MEMORANDUM

SUBJECT: Proposed Amendment to Waterfront Overlay Regulations

RE: Rebekah Baines Johnson Center Redevelopment Project
Water Quality Treatment – Approach and Methodology
21 Waller Street (±17.40-Acres)
Austin, Travis County, Texas

RBJ CENTER
21 WALLER STREET
AUSTIN, TRAVIS COUNTY, TEXAS
WATER QUALITY EXHIBIT

Proposed redevelopment including water quality controls

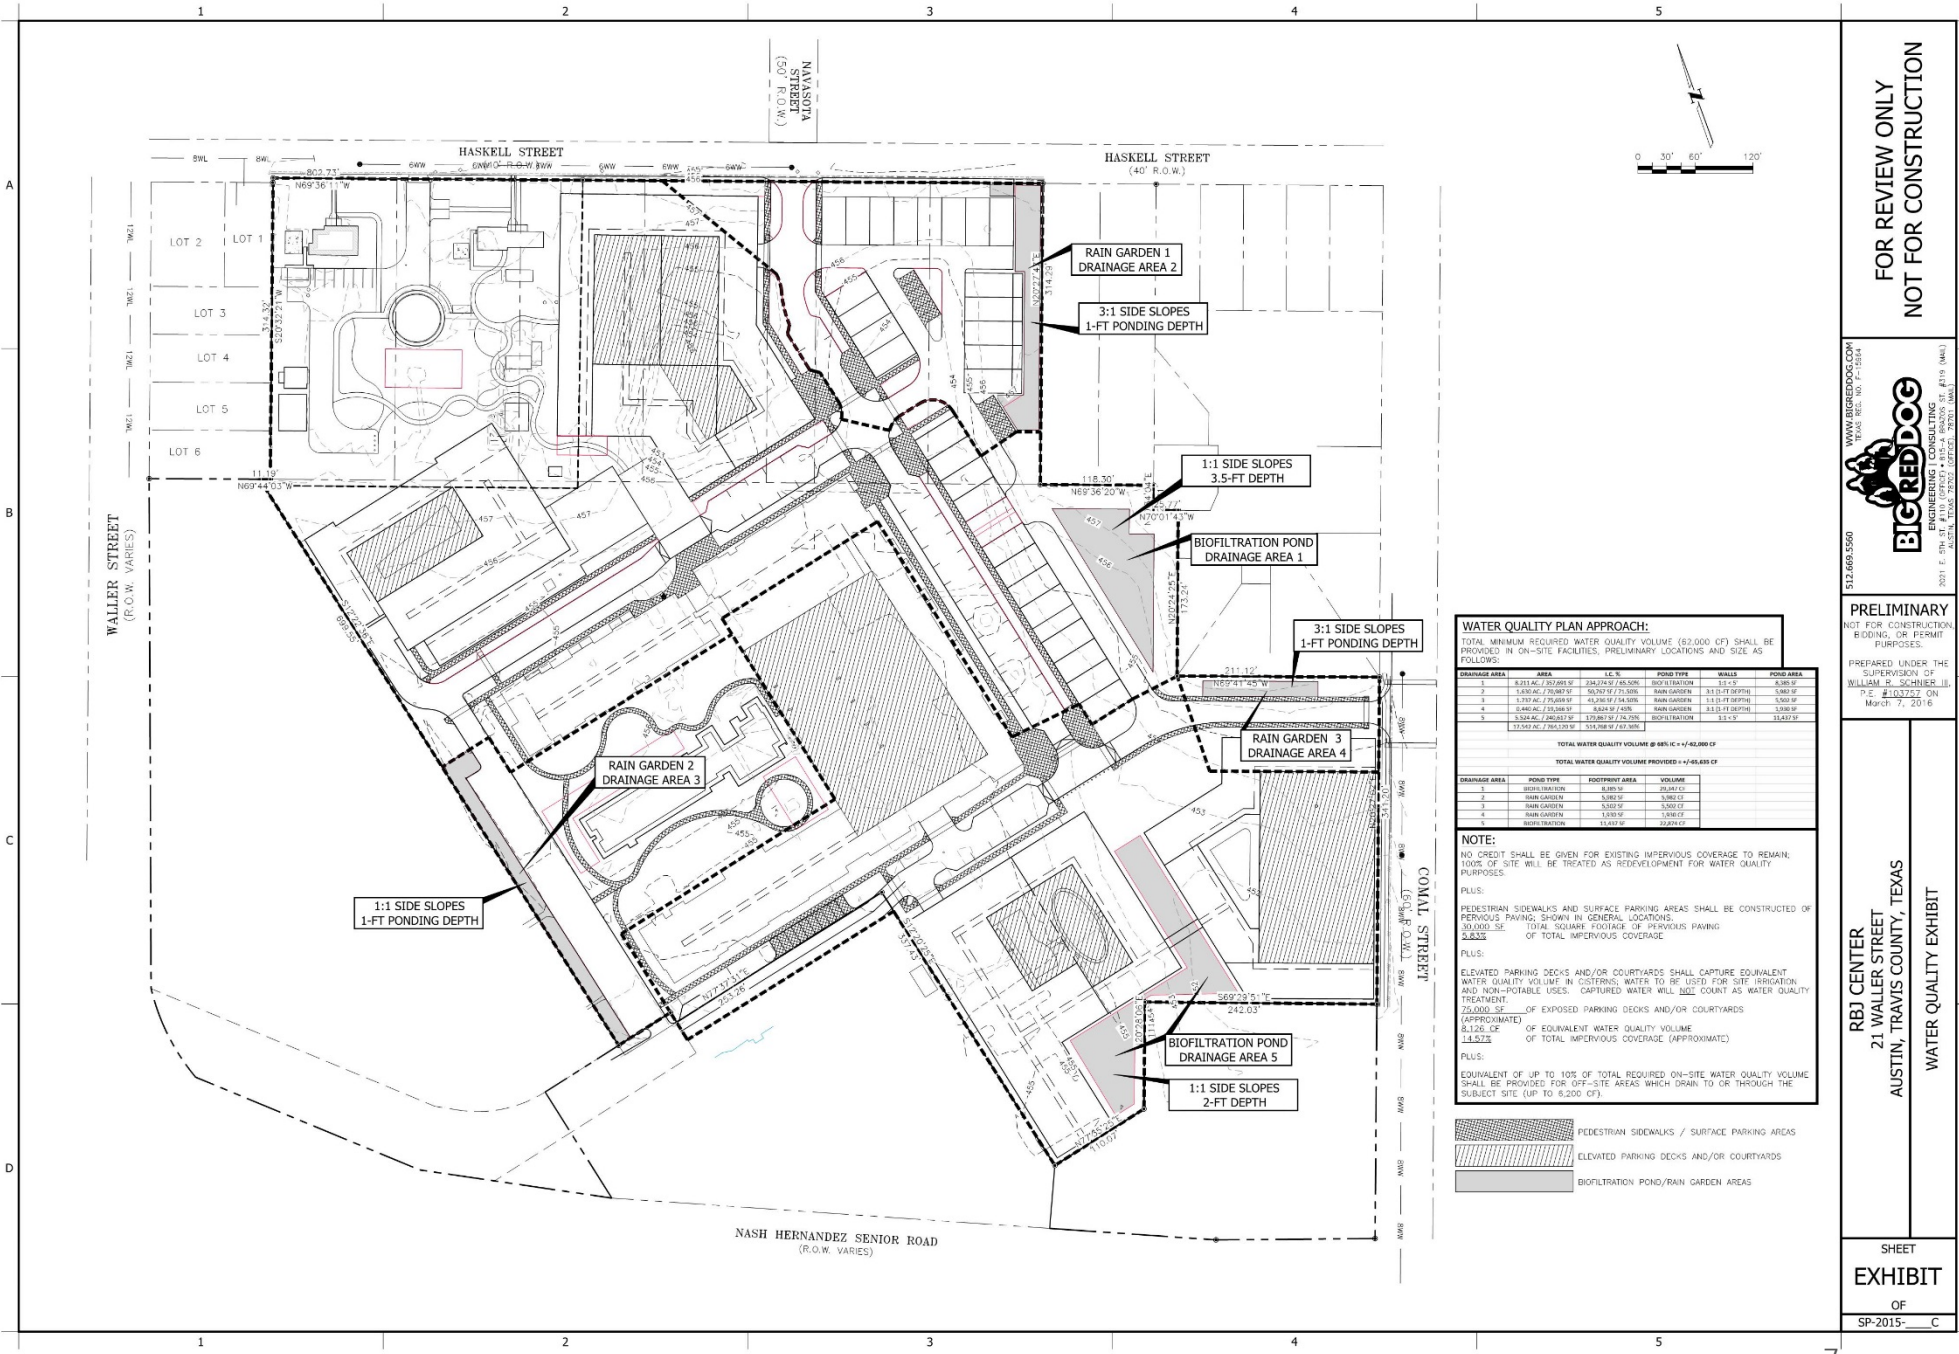
Is current proposal the “maximum extent feasible”? Development team asserts that it is.

- Exceeds current impervious cover limit (40%) by approx. 70%
- Increases water quality treatment by 35% by including existing impervious cover and pervious pedestrian areas
- Engineer estimates cost of water quality enhancements to be \$450-560,000 above minimum
- Developer estimates approx. \$4.0M in land sales with 41% impervious cover and \$12.3M in sales based on 68% impervious cover
- Developer has said that the increased impervious cover is necessary to fund critical improvements to RBJ residential tower and construction of affordable senior housing

Basis for financial projections was not provided to City so staff is unable to confirm that it is maximum extent feasible and still have an economically viable project
